Construction Division
Additions & Alteration Charges Approval Form

GULMOHAR RESIDENCY

Details of Additions & Alterations

Flat No	302	Block no.	' F '
Flat Area	1360 sft	Type	Deluxe / Luxury
Buyer Name	Sanjay Majumder		
Phone No.	9581004400	Email

Changes in kitchen platform: (mark on plan)

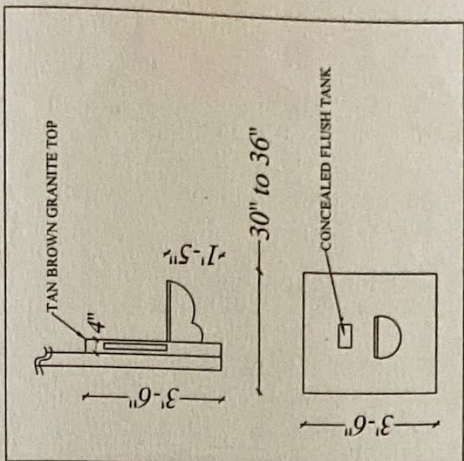
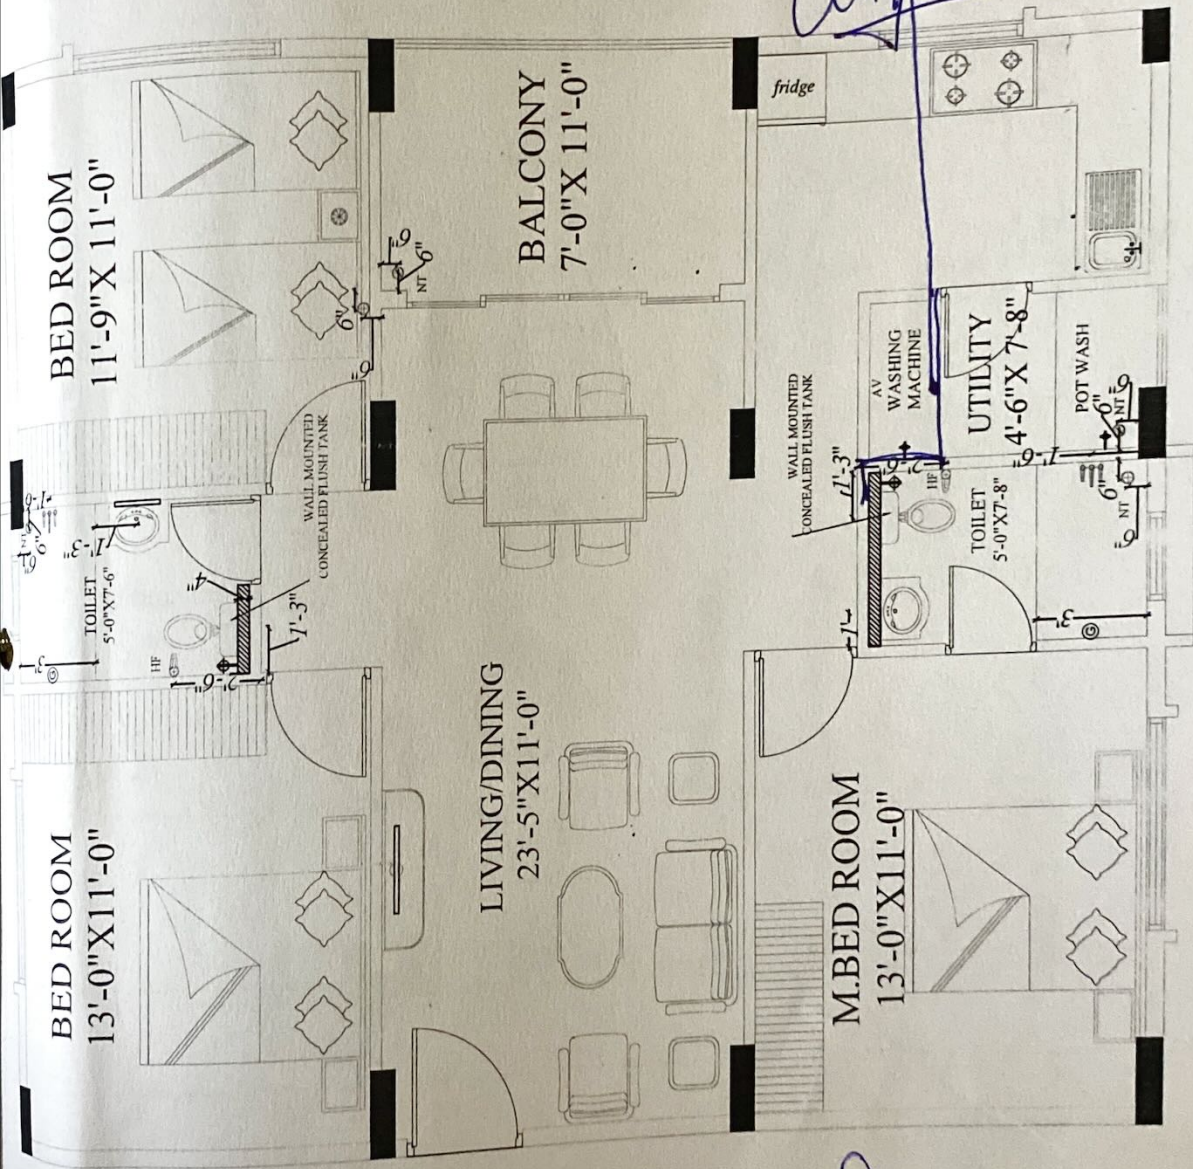
→ Granite not required

→ 4" skirting required on kitchen platform
